ADDENDUM

PROJECT: DOT-200009 Putnam County FSMF

ADDENDUM NO.: 2

PUTNAM COUNTY FSM FACILITY FOR OHIO DEPARTMENT OF TRANSPORTATION

C3.0
UTILITY PLAN

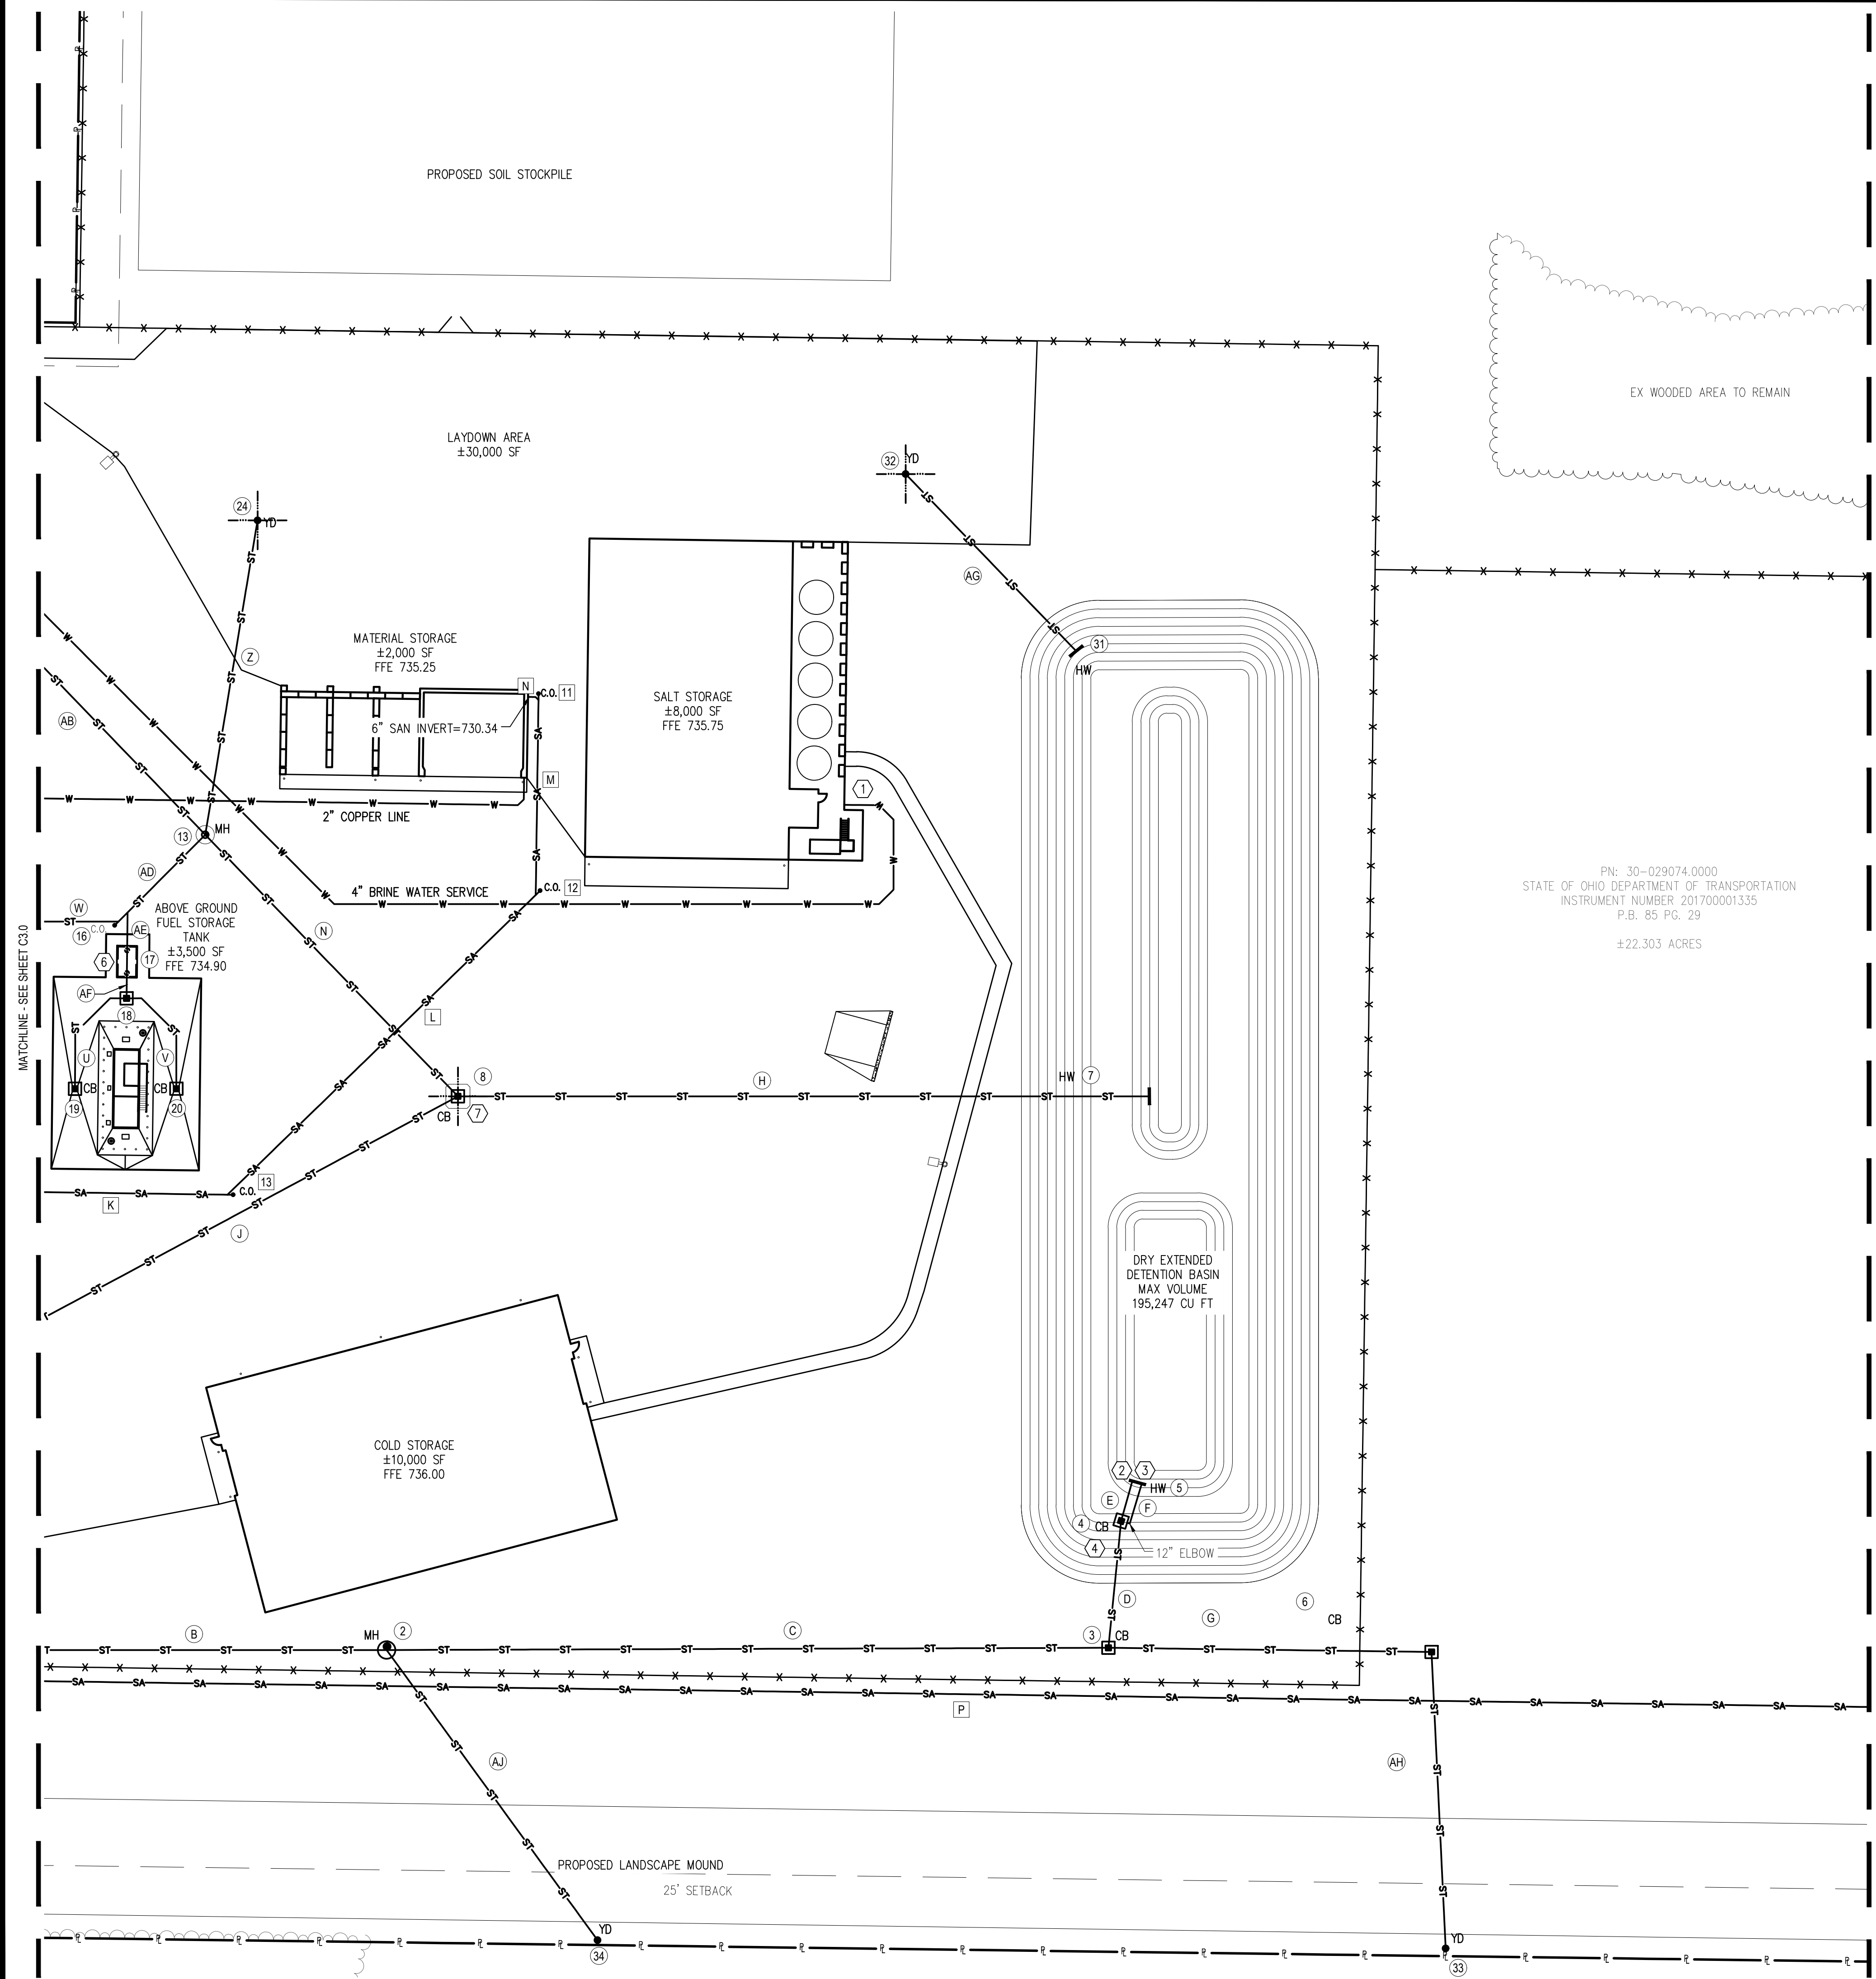
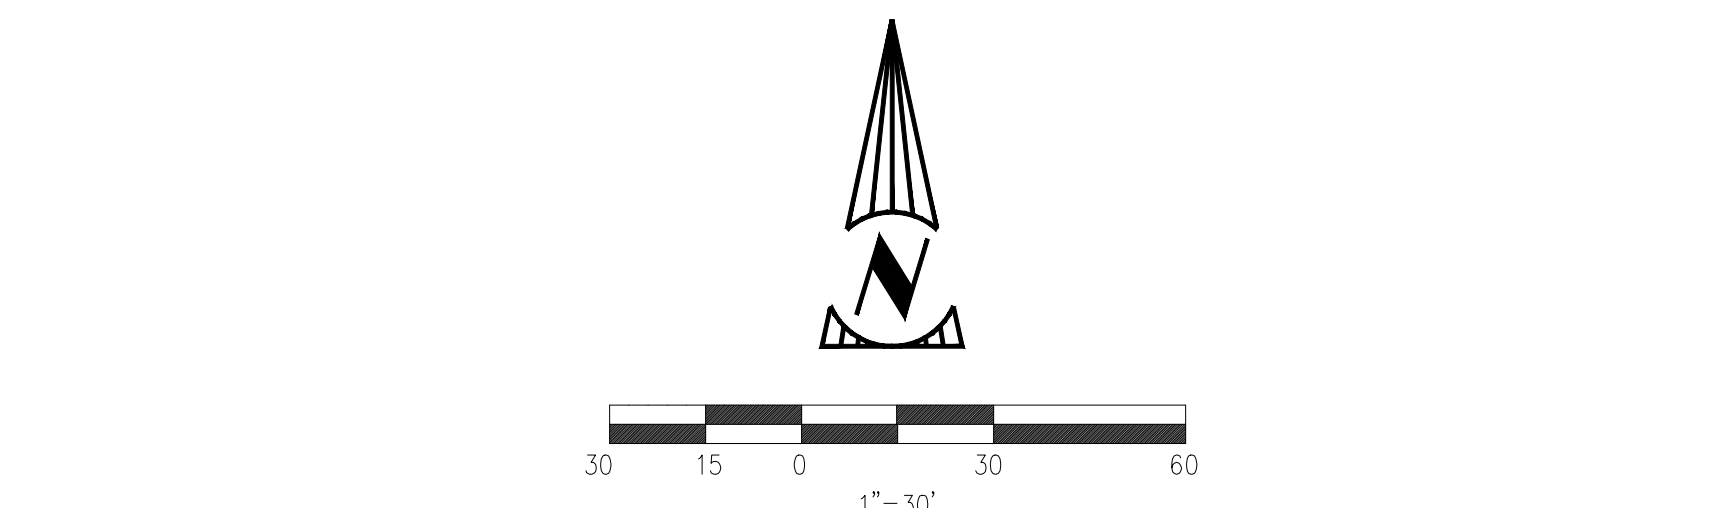
- RFI: The waterline is called out as C-900. Village of Ottawa spec is C-909. Please verify which is required.
 - Response: C-909 should be used as required by the Village of Ottawa.
- RFI: Would HDPE be acceptable for the 2" force main?
 - Response: 2" DR11 PE pipe is acceptable for the force main.

C3.1
UTILITY PLAN

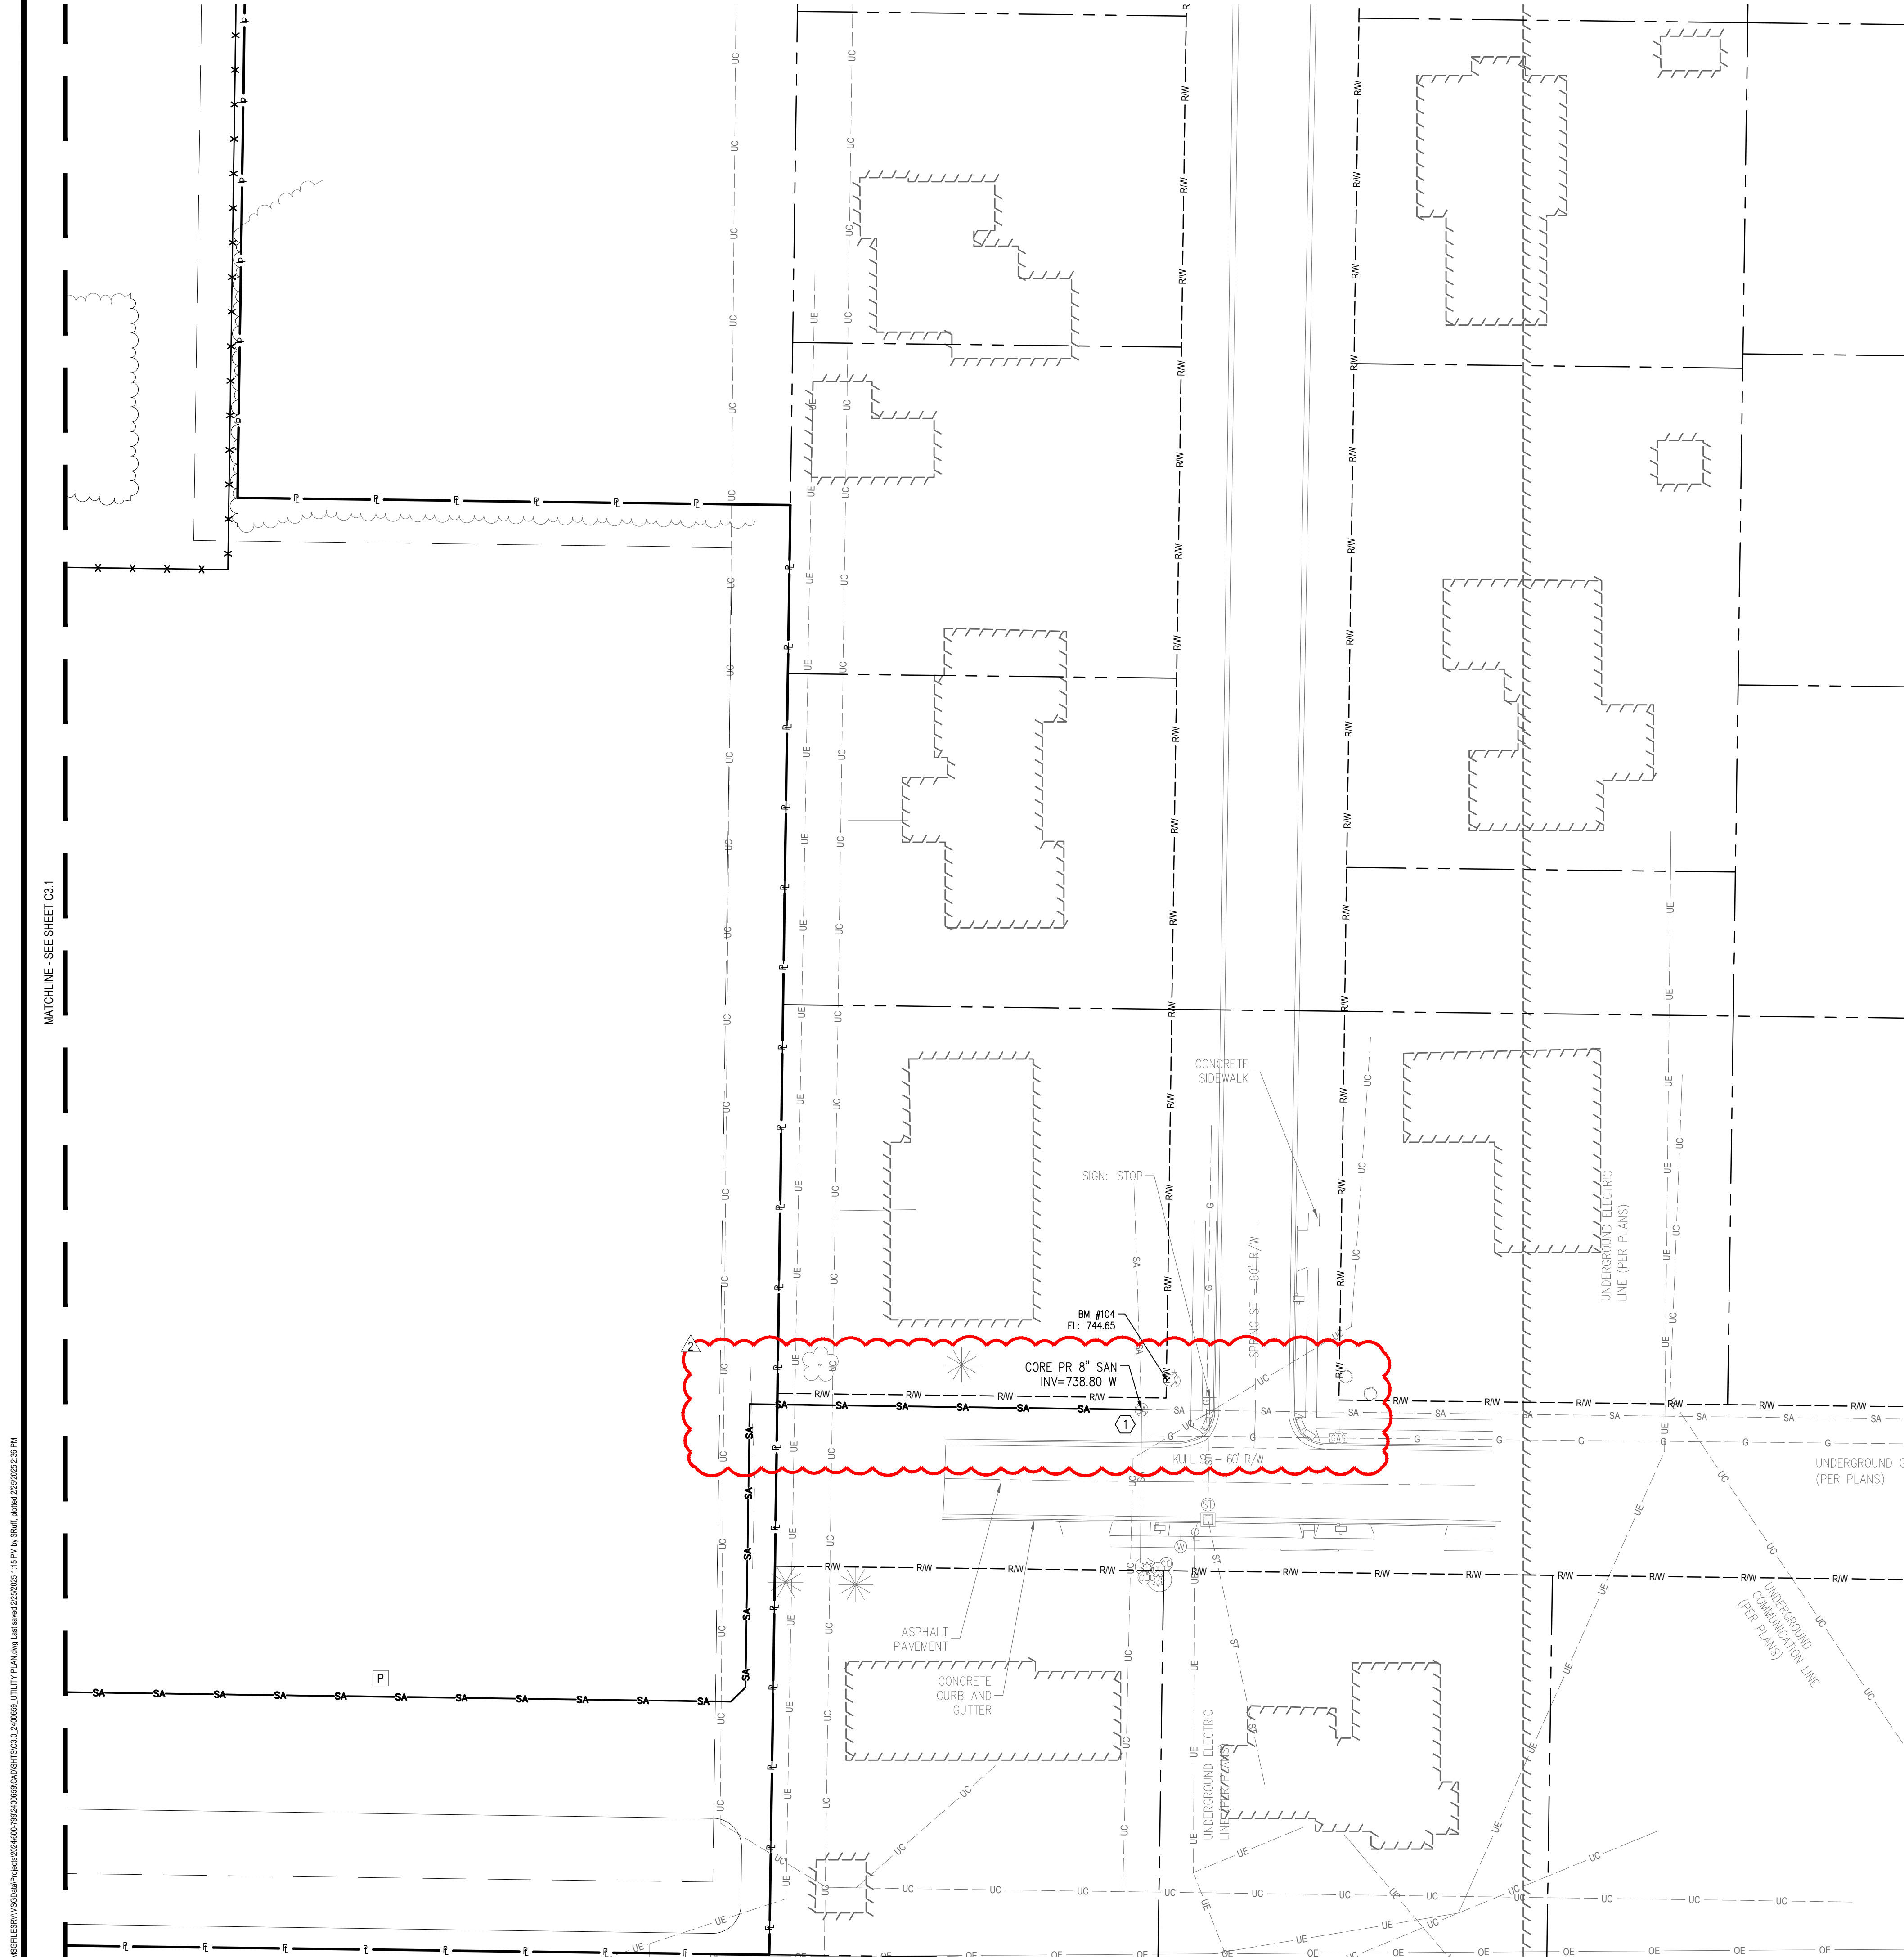
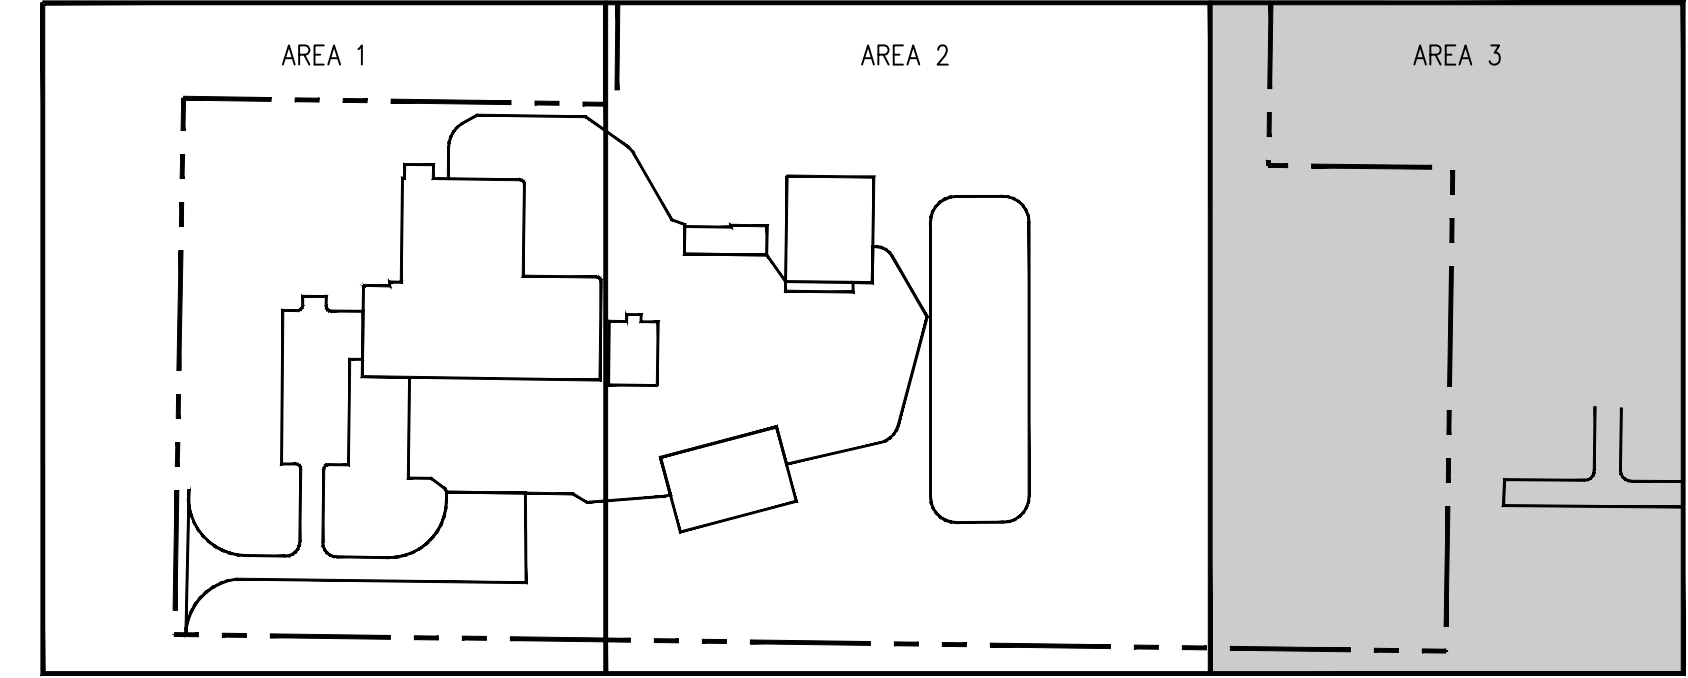
- RFI: Sheet C3.1 - structure 16 which is a clean out is 15" pipe flow line. Are we to reduce to a typical 6" cleanout or place a catch basin?
 - Response: Our intent was to reduce to a 6" clean-out.
